# Memo

File No: Z07-0070

At: 455 Cavell Pl

Purpose: To rezone the subject property from the A1 - Agriculture 1 zone to the RU1h - Large Lot Residential (Hillside Area) zone to facilitate a residential subdivision.

MAP "A"

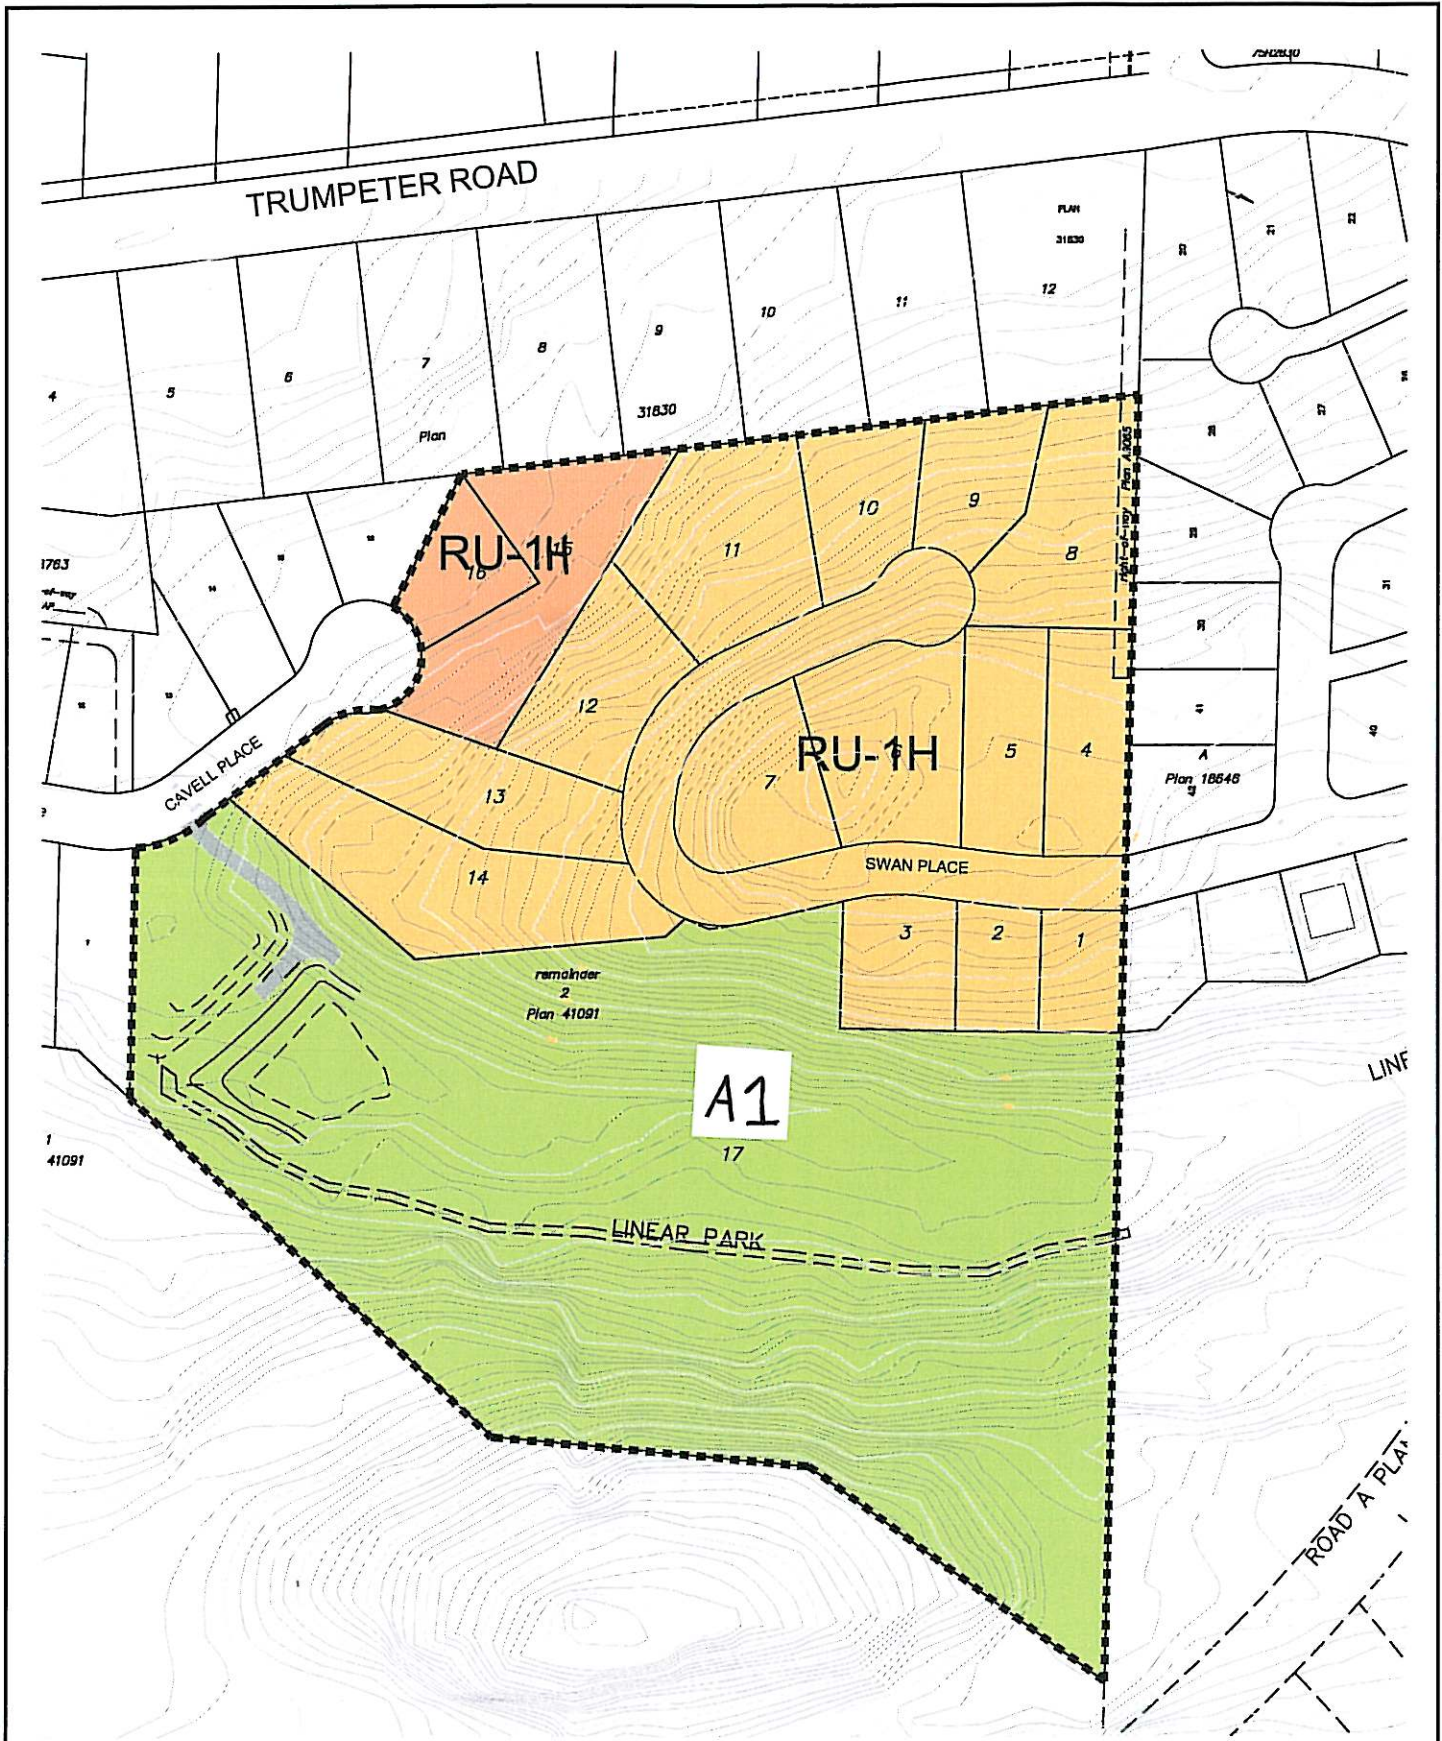
It is commendable that the applicant will dedicate the remainder of the site, which is either in excess of 30% slope or identified as wetland/stream, for preservation as a linear park. This area shown as A1 on the attached "Proposed Rezoning Plan" map, will be zoned at a later date to P3 - Parks & Open Space with a concurrent OCP amendment application.
